Village of Arlington Heights
Conceptual Plan Review Committee
Community Room, 3rd Floor
33 S. Arlington Heights Rd.
July 14, 2021
6:30 PM

Item: 1016 W. Campbell St. Subdivision - T1742

Temp File Number: T1742
Project Title: 1016 W. Campbell Subdivision
Location: 1016 W. Campbell Street
PIN: 03-30-306-019

Temp File Number: T1745
Project Title: 630 W. Northwest Hwy Bank
Address: 630 W. Northwest Hwy.
PIN: 03-30-402-012-0000

2105.2414
BOUNDARY SURVEY
COOK COUNTY

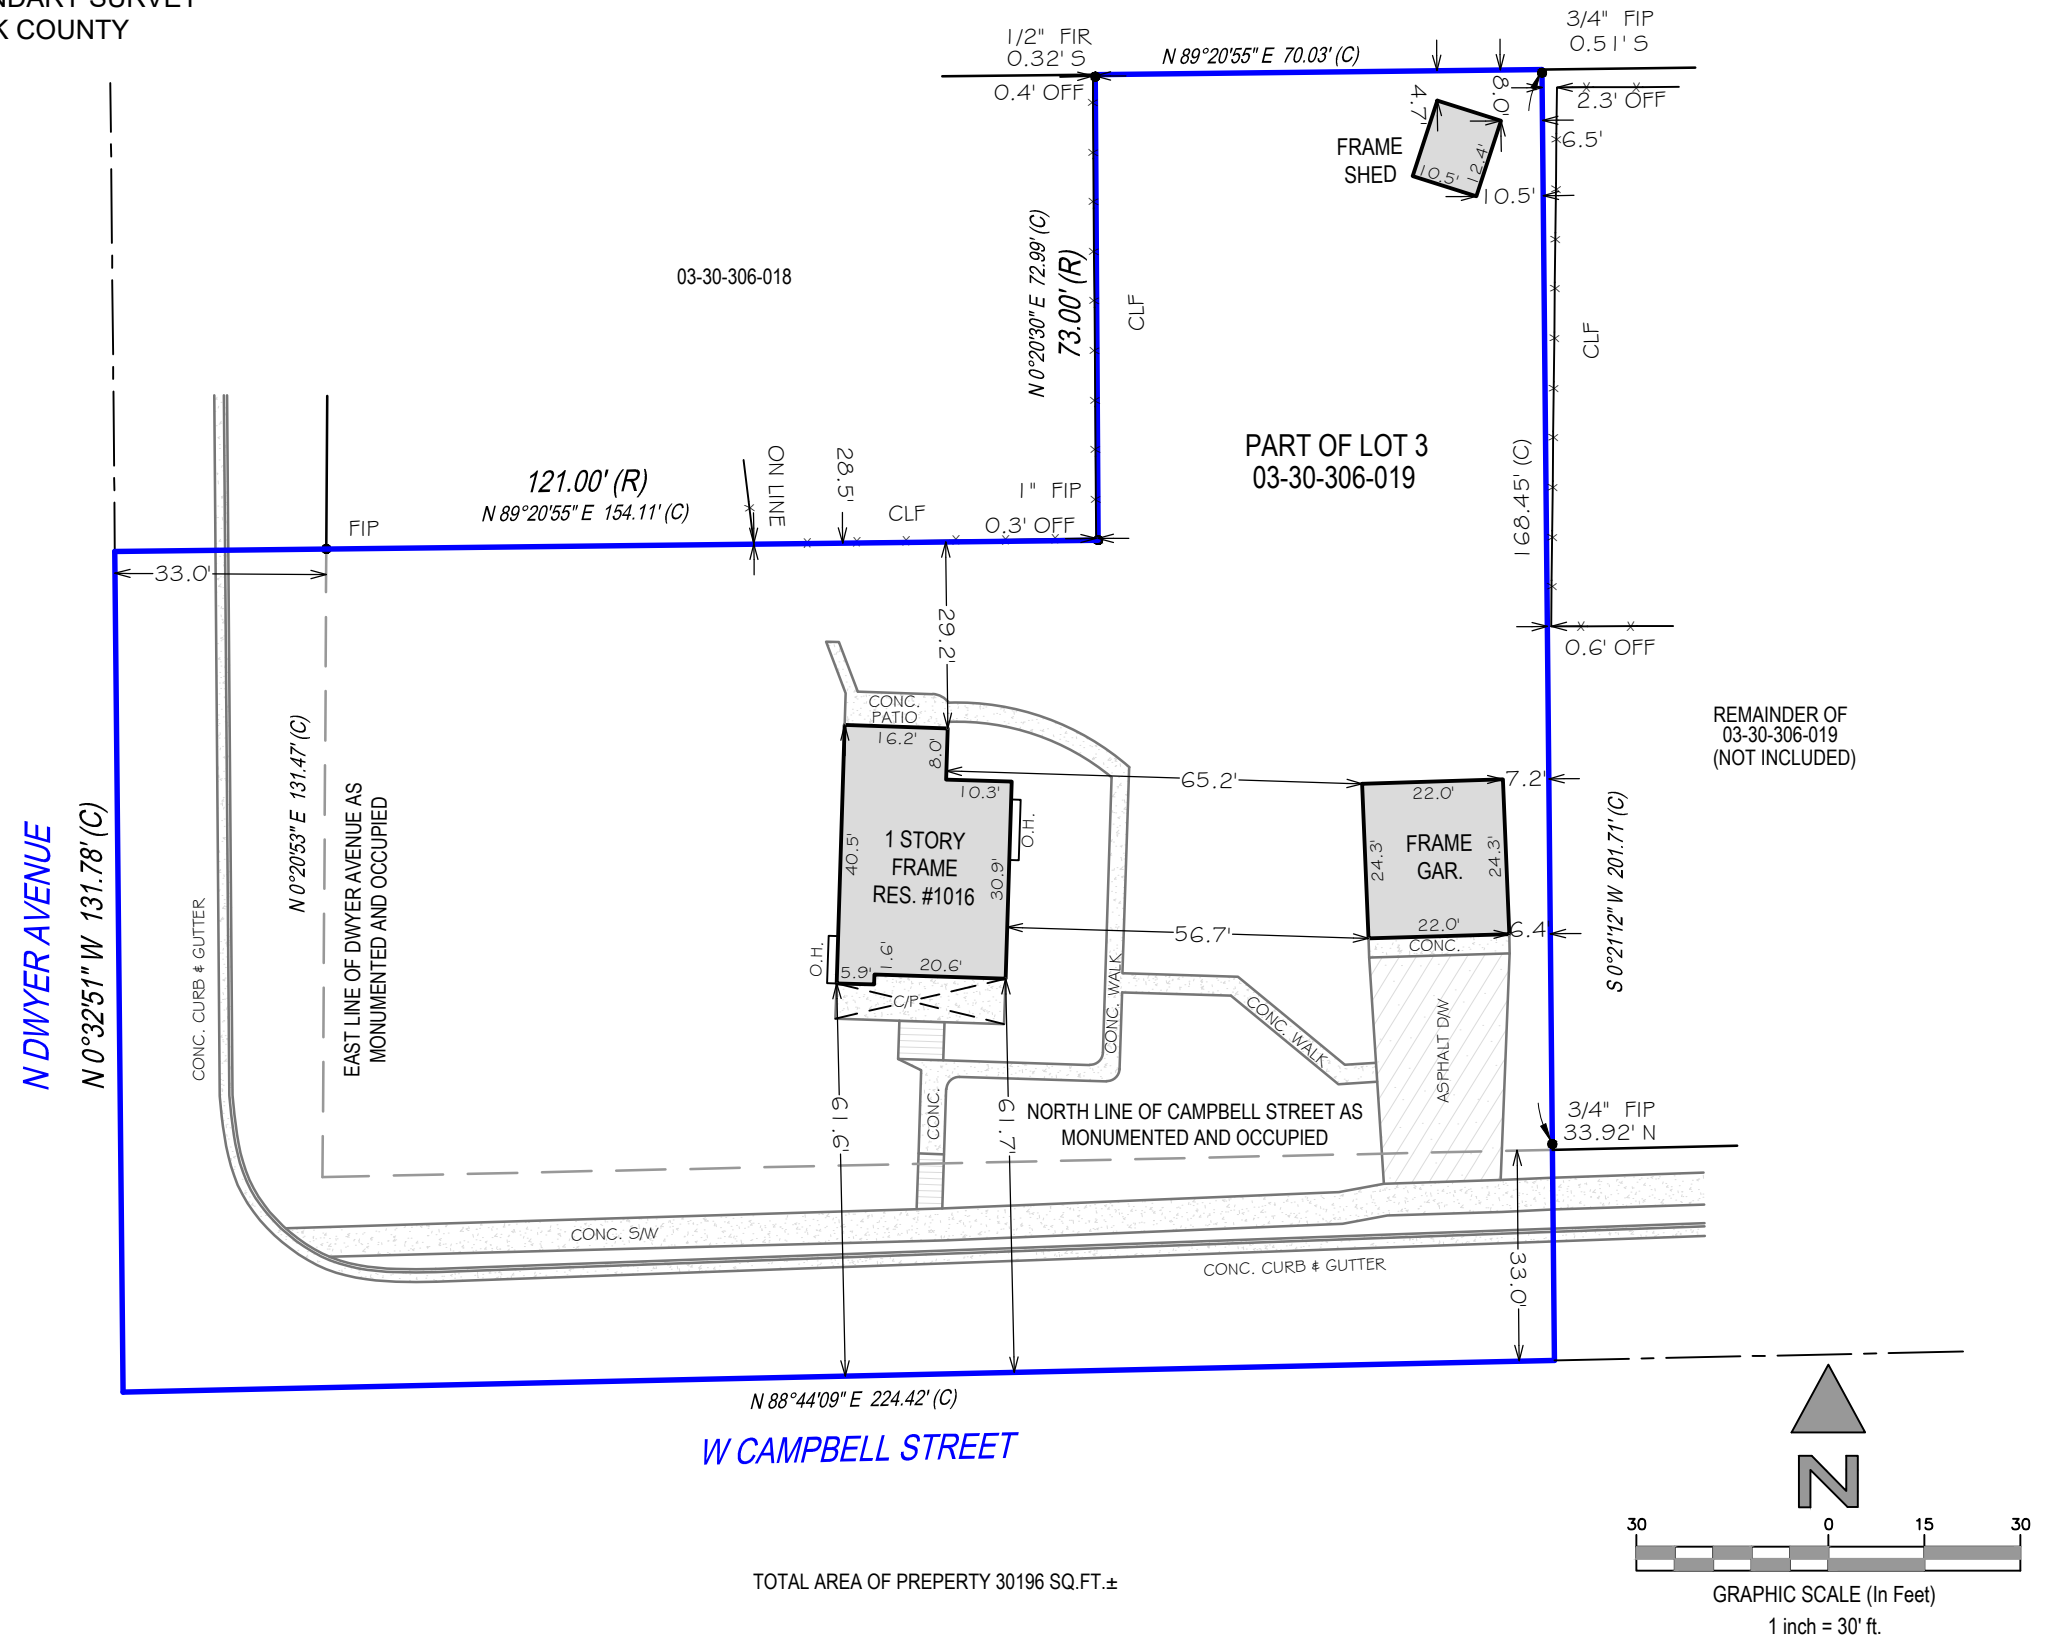
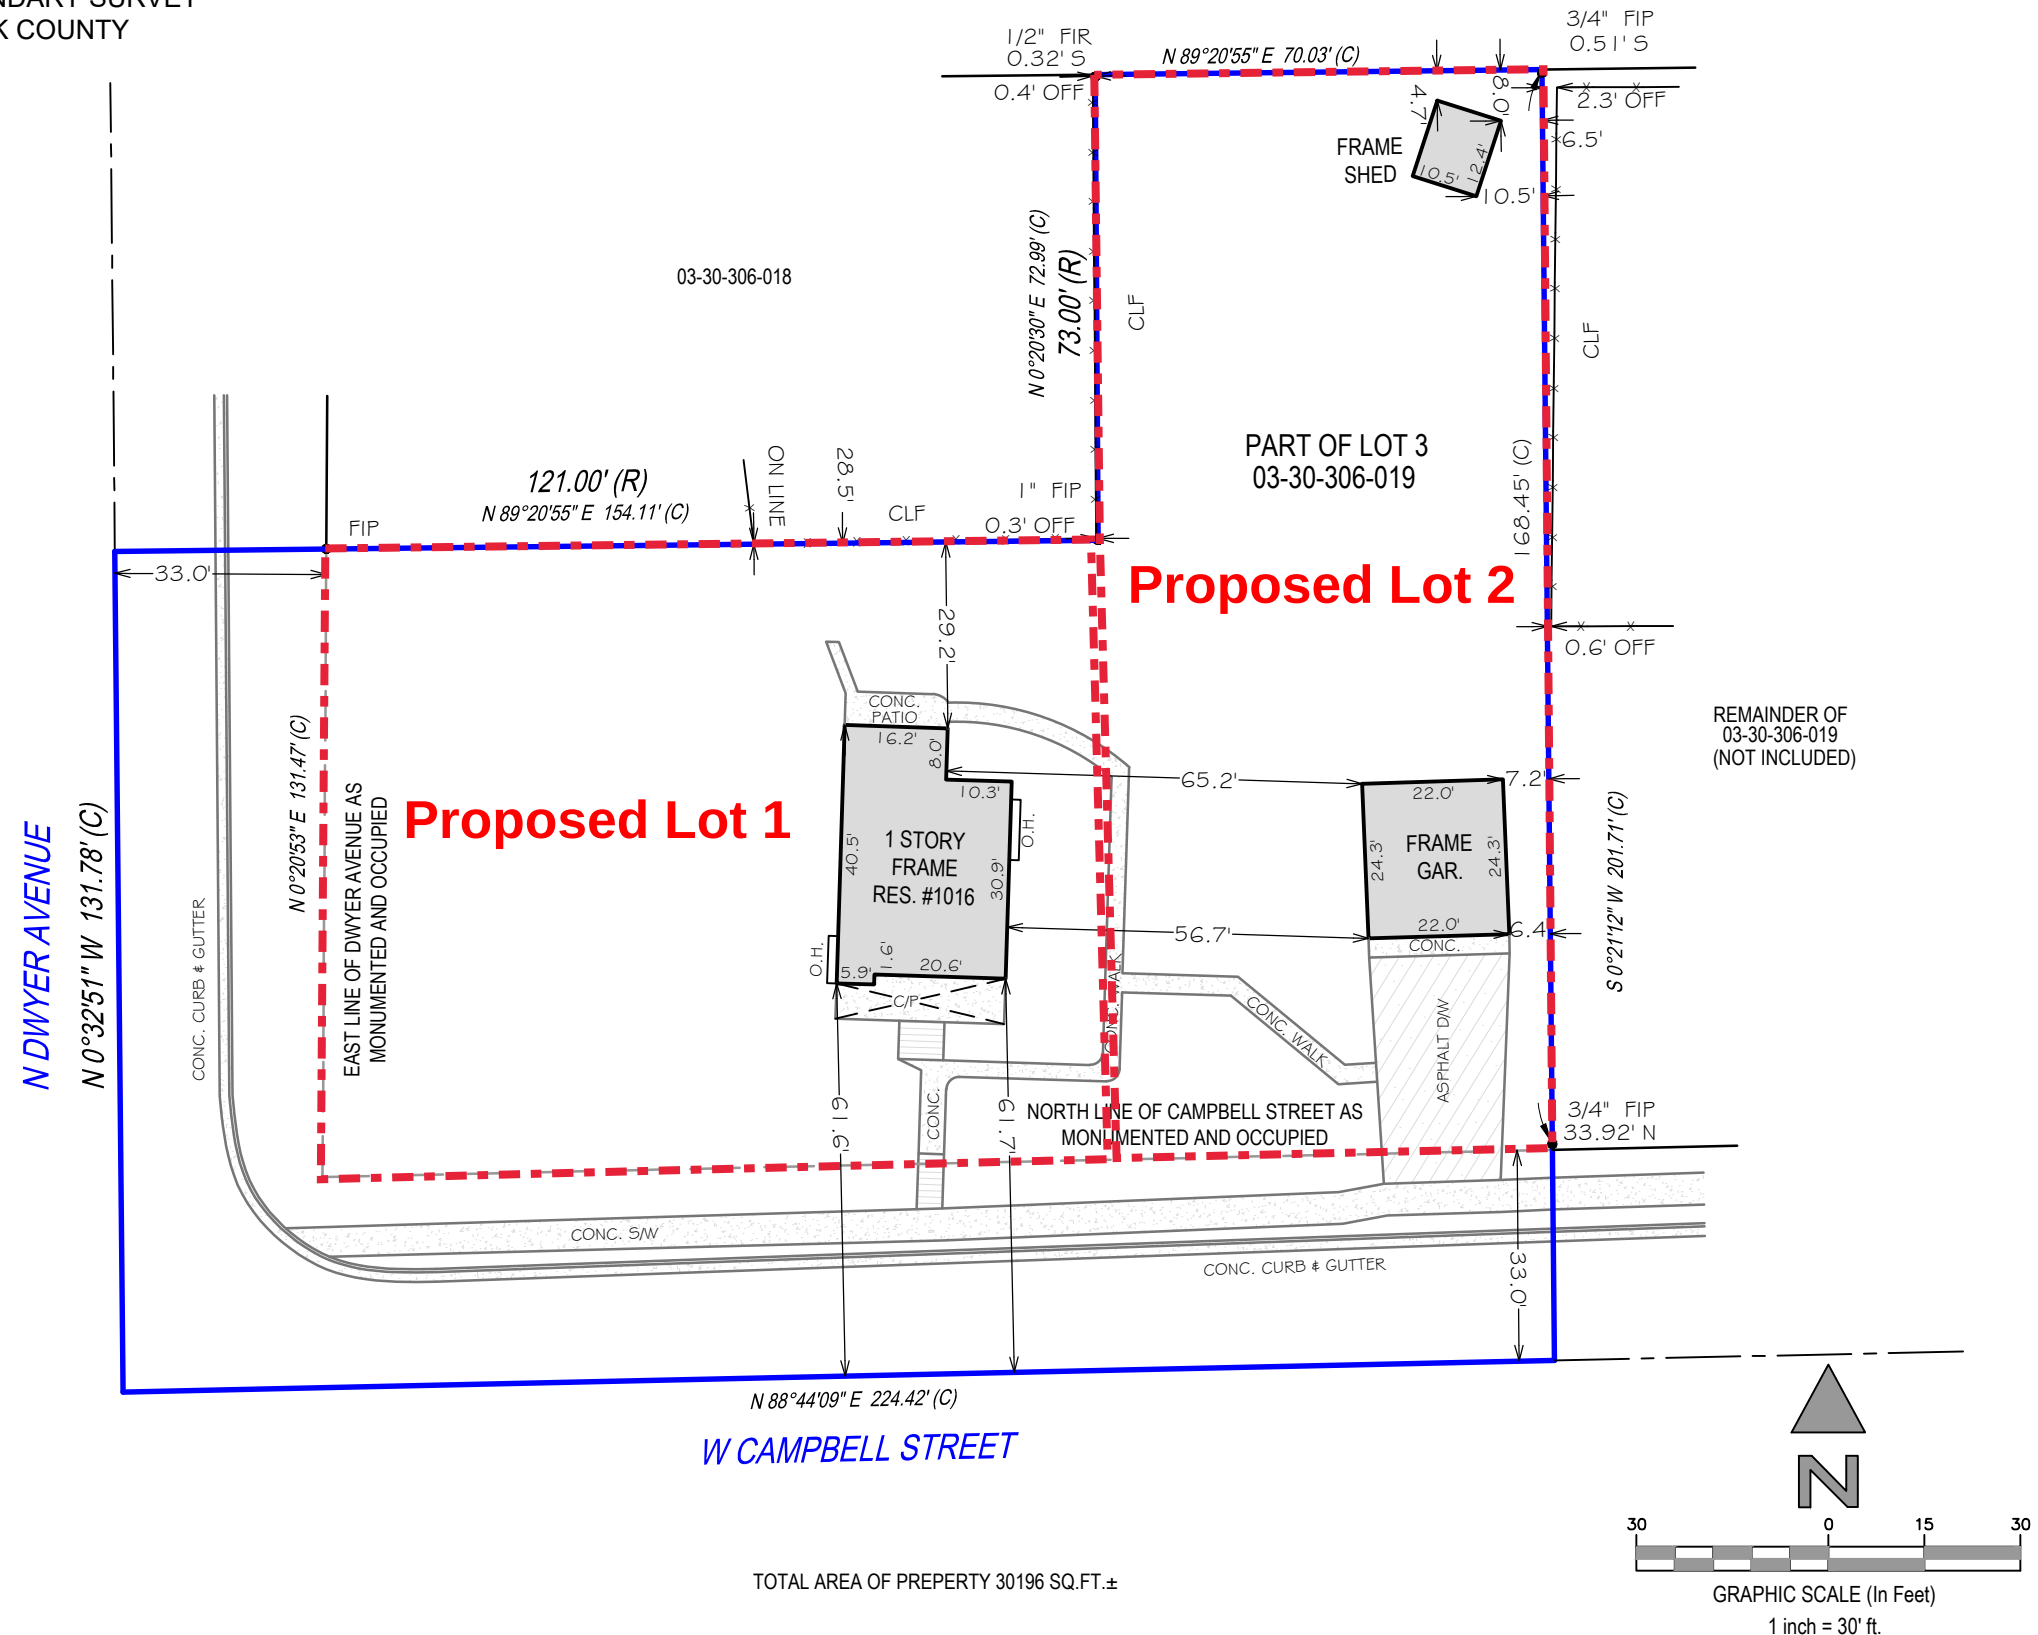
Additionally, the proposed lot line that would divide the site into two lots would be located approximately 13.8 feet east of the existing home on Lot 1. Given the orientation of Lot 1, the area east of the existing house is defined as a rear yard and therefore a 30' rear yard setback is required. The following variation would be required:

The petitioner could adjust the location of the dividing line between the two lots and push it further west to create a code compliant 75' width for Lot 2, however, this would further reduce the rear yard setback for Lot 1, whereby exacerbating the rear yard setback variation. For each requested variation, the petitioner must demonstrate conformance with the standards of approval as outlined within the zoning code. A written justification addressing each standard for each requested variation shall be required:

The front yard setback for Lot 2 will be based on the existing setback of the homes along the Campbell Street frontage. Specifically, the required setback will be determined by the average setbacks of all the existing homes on the frontage, which is the north side of Campbell between Dwyer and Kennicott. The petitioner will need to provide an exhibit showing these setbacks, which will allow staff to calculate the code required front yard setback for Lot 2 and the code required exterior side yard setback for Lot 1. With regards to the required front yard setback on Lot 1, it will be based on the average setback of the existing homes on the Dwyer frontage, which is the east side of Dwyer between Campbell and Wing Street. An exhibit showing these setbacks must also be provided.

east side of Lot 1. Therefore, the only viable location would likely be to the north/northwest of the existing home with access coming from a curb cut along Dwyer. This would place the garage in a non-compliant location as garages are only allowed within a rear yard, and depending on the final placement of said garage, it would likely end up in the side or front yard and would require a variation. As part of the subdivision process the petitioner must provide a plan for the code required garage that will need to be constructed on Lot 1. As a condition of any subdivision approval, the existing detached garage would need to be demolished and a new garage and driveway for the existing home on Lot 1 would need to be constructed.

3. The petitioner must provide a design for the code required two-car garage, curb cut, and driveway on Lot 1, for review and approval by Staff. Said improvements must be constructed at time of demolition of the garage on proposed Lot 2.

8. The petitioner shall provide an exhibit showing all existing building setbacks along the north side of Campbell Street, east of Dwyer Avenue and west of Kennicott Avenue, as well as the existing building setbacks along the east side of Dwyer Avenue, north of Campbell Street and south of Wing Street.

Site Plan & Floor Plan

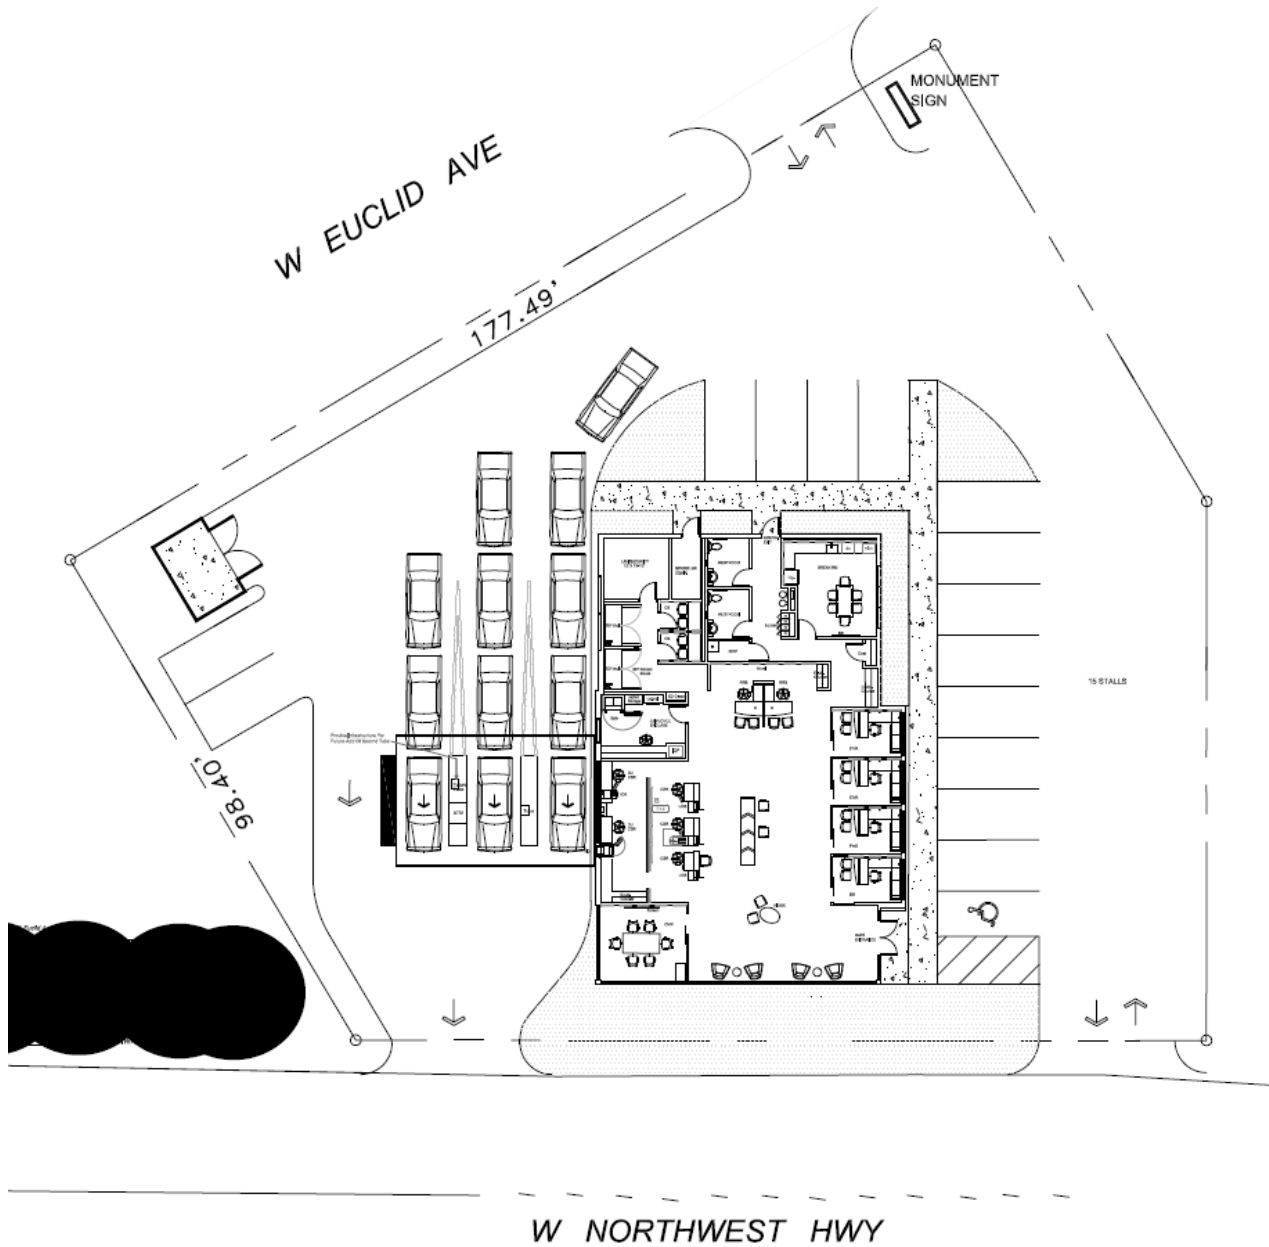
The applicant has provided a preliminary site plan for review. The plan shows three driveways, with one connecting to Euclid Avenue and two connecting to Northwest Highway. Staff has concerns regarding access to and from these driveways, given the high levels of traffic on these roads as well as the close proximity of the driveways to the Euclid-Northwest Highway intersection. The function of these driveways and their potential impact on traffic will need to be evaluated in a traffic and parking study. If the study indicates potential access issues or a significant negative impact on adjacent roadways, access restrictions including but not limited to utilization of right-in, right-out driveways may be required. IDOT approval shall be required for the proposed modifications to access along Northwest Highway. Cook County approval shall be required for the proposed modifications to access along Euclid Avenue.

Additionally, Staff believes the dumpster enclosure should be shifted south to reduce visibility from Euclid Avenue, with the two parking spaces shifted north. Proposed landscape screening along Euclid Avenue, Northwest Highway, and the east and west property lines will be evaluated for compliance with code. The petitioner is also proposing ground signage along both Northwest Highway and Euclid Avenue, which will be evaluated during the Plan Commission process once finalized plans are provided. Current plans do not include a scale or measurements for the proposed location of the signs, nor have sign elevations been provided.

2. Scaled floor plans, engineering plans, and site plans shall be provided.
3. A Design Commission Application shall be required.
4. The petitioner shall work with Village Staff to develop a landscape plan for the site. Onsite landscaping will be evaluated during the Plan Commission review process.

5. Sign Elevations and a scaled site plan showing all improvements (including signage) shall be provided. As part of the Plan Commission process, proposed signage will be reviewed for conformance with Village Code.
